Access Compliance Report

Public Rights-of-Way

(Curb Ramps)

Intersection ID: 27446	Main Street: BALLANTYNE_MEADOWS_DR	Cross Street: VALLEY_SPRING_DR	Location:	N
ADA ID: 3D244FBB1327	Ramp Type: PerpDiag	Initial Pass/Fail: Fail	Overall Compliance: No	Severity Score: 12.5
Codes/Mitigation Info/Possible Solution		Field Measurements/Component Compliance

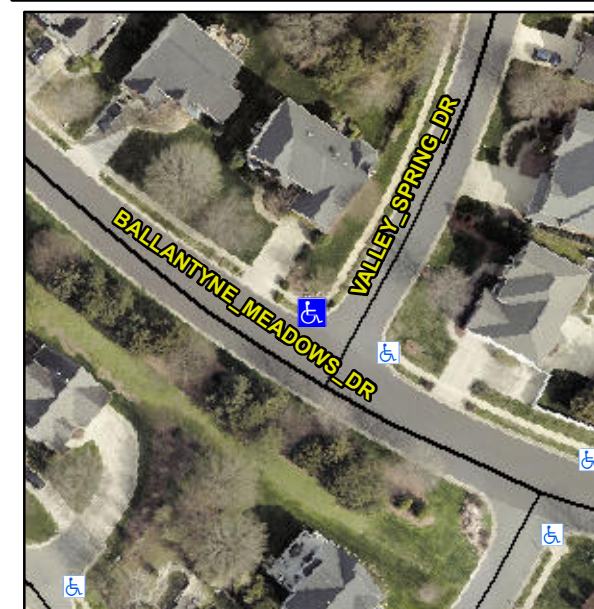
Not Found, R304.2.2

Compliance	Description	Data	Compliance	Description	Data
N/A	Ramp Length (in)	41.0	No	Ramp Slope (%)	8.5
Yes	Ramp Width (in)	48.0	Yes	Ramp XSlope (%)	2.0
N/A	Flare Type LT	N/A	N/A	Flare Type RT	N/A
N/A	Flare Slope LT (%)	N/A	N/A	Flare Slope RT (%)	N/A
N/A	Flare Traversable LT?	N/A	N/A	Flare Traversable RT?	N/A
N/A	Landing Length (in)	N/A	N/A	DWS Provided?	N/A
N/A	Landing Width (in)	N/A	N/A	DWS Contrast?	N/A
N/A	Landing Slope (%)	N/A	N/A	DWS Length (in)	N/A
N/A	Landing X Slope (%)	N/A	N/A	DWS Full Width?	N/A
N/A	Landing Curb? (Y/N)	N/A	N/A	DWS Offset (in)	N/A
N/A	Shared Landing?	N/A			
N/A	Gutter Ponding?	N/A	N/A	Gutter Slope (%)	N/A
N/A	Gutter Lip Ht (in)	N/A	N/A	Gutter X Slope (%)	N/A
N/A	Painted X Walk1?	No	N/A	Painted X Walk2?	No
	X Walk 1 Direction	To SW		X Walk 2 Direction	To SE
N/A	X Walk 1 Width (in)	N/A	N/A	X Walk 2 Width (in)	N/A
	X Walk 1 Slope (%)	3.4		X Walk 2 Slope (%)	1.7
	X Walk 1 X Slope (%)	2.9		X Walk 2 X Slope (%)	0.8

Remove & Replace Curb Ramp With Two New Directional Ramps or Equivalent.
